RE: **Agenda Item B.6, September 23, 2024, Regular Council – Land Use
Development Application No. 7923-0124-00
Replacement Page for the Planning Report**

After finalizing the Planning Report for the September 23, 2024 Regular Council – Land Use Agenda, it was determined that there were errors in the TREES section of the report and Appendix II. (Summary of Tree Survey, Tree Preservation and Tree Plans).

Pages 9 and 14 of the Planning Report have been updated to reflect this change.

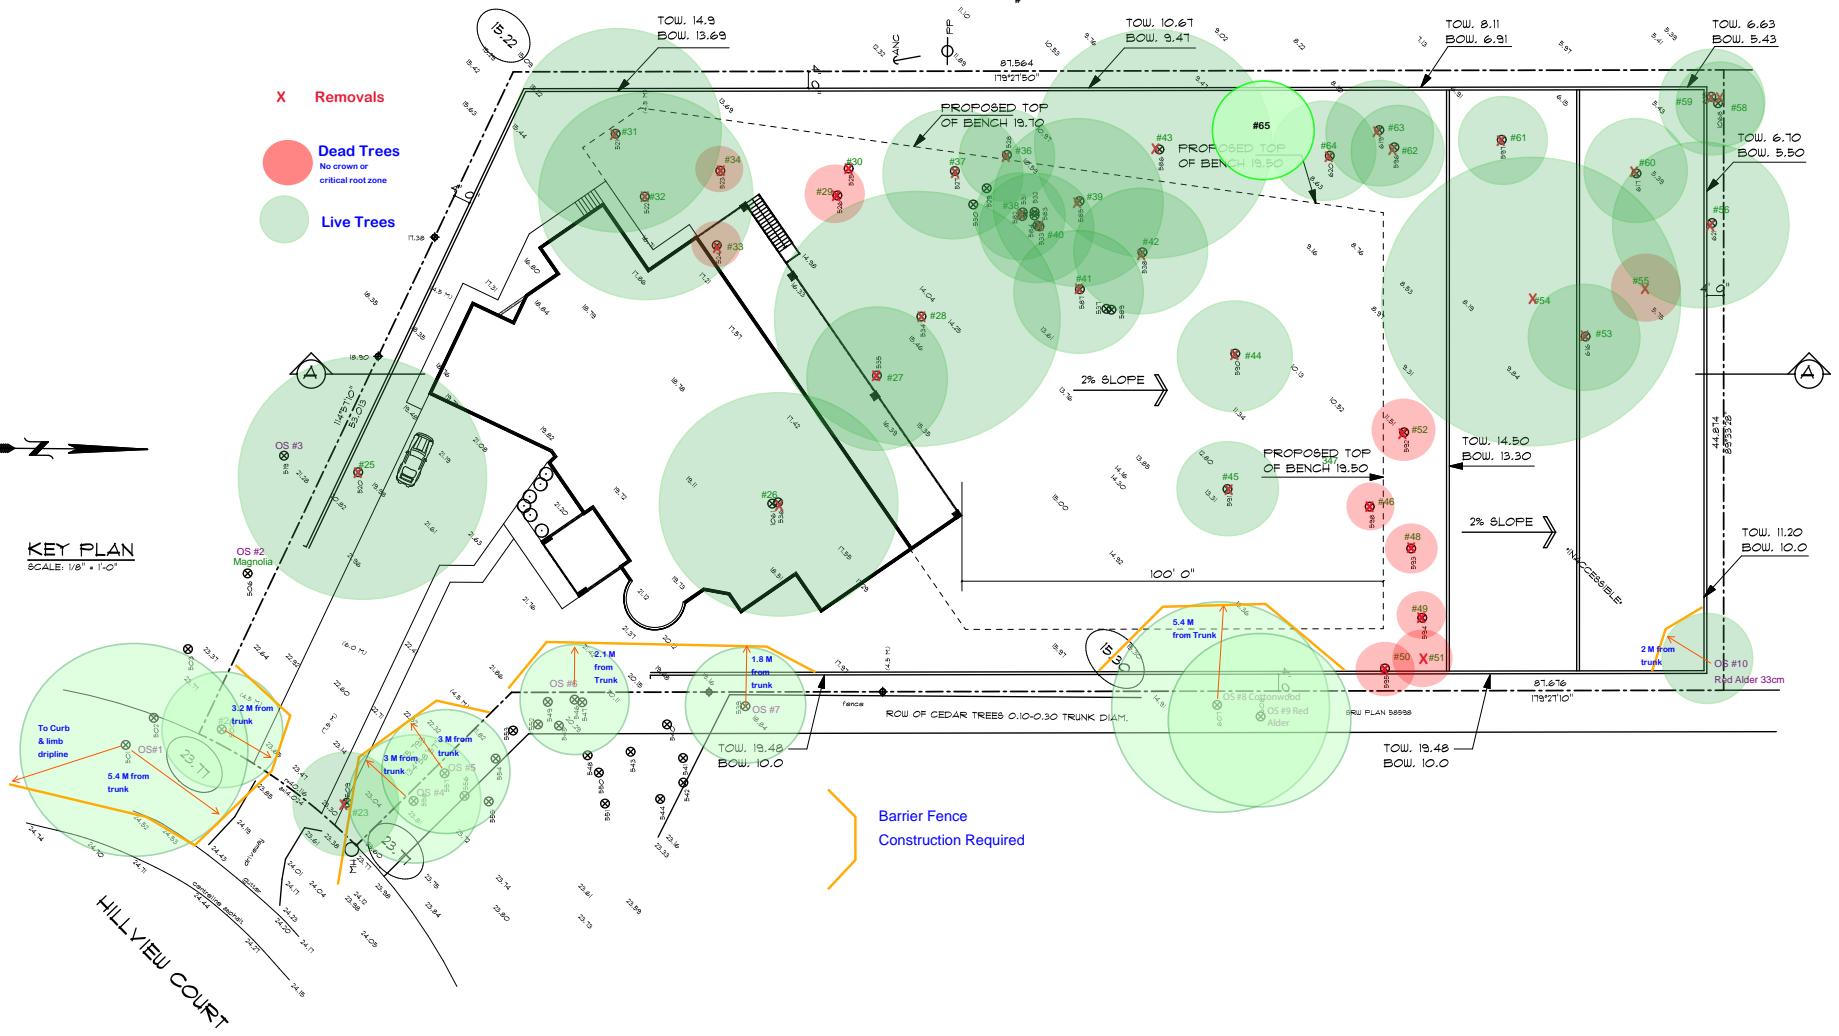
- For those trees that cannot be retained, the applicant will be required to plant trees on a 1 to 1 replacement ratio for Alder and Cottonwood trees, and a 2 to 1 replacement ratio for all other trees. This will require a proposed total of ~~42~~⁵² replacement trees on the site. After deduction of the 10 Alder trees which are already deceased, a total of ~~32~~⁴² replacement trees are required on the site.

- The arborist proposes a tentative tree ~~management~~^{replacement} plan, indicating 20 replacement trees. Since the proposed ~~32~~⁴² replacement trees cannot be accommodated on the site, a proposed deficit of ~~12~~²² replacement trees would require an estimated cash-in-lieu payment of ~~\$6,600.00~~^{\$12,100.00}, representing \$550 per tree, to the Green City Program, in accordance with the City’s Tree Protection By-law.

- In summary, a total of 21 trees are proposed to be retained or replaced on the site with an estimated contribution of ~~\$6,600.00~~^{\$12,100.00} to the Green City Program.

Red-line comment: This insert replaces the previous Tree Preservation Summary (Appendix II)
